# 1981 Corvette: Service Bulletin: Whistle or Whine in Reverse or Lo 1 at Idle - THM 350C (MX3)

**Subject:** Whistle or Whine in Reverse or Lo 1 at Idle - THM 350C (MX3)

**Model and Year:** 1981 Corvette with THM 350C (MX3)

**Bulletin No:** 81-T-20

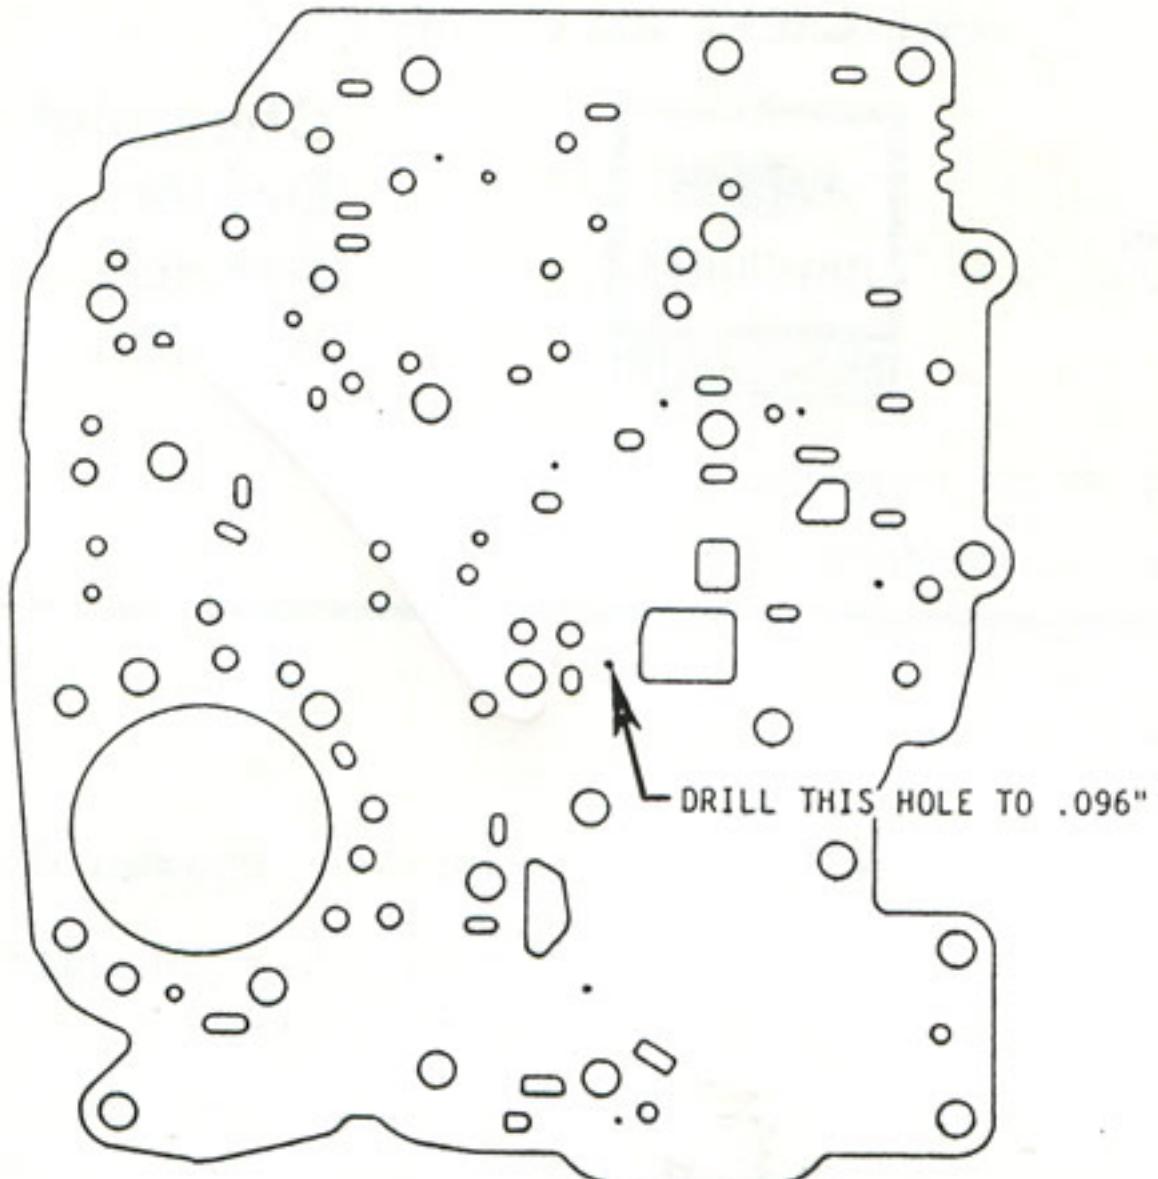
Some 350C transmissions in 1981 Corvettes and Camaros may emit a whistle or whine in Reverse or Lo1 at base idle. This is caused by the valve body spacer plate hole shown in the illustration.

To correct noise, enlarge the hole using a No. 41 drill (.096) and remove any burrs formed on either side of the plate.
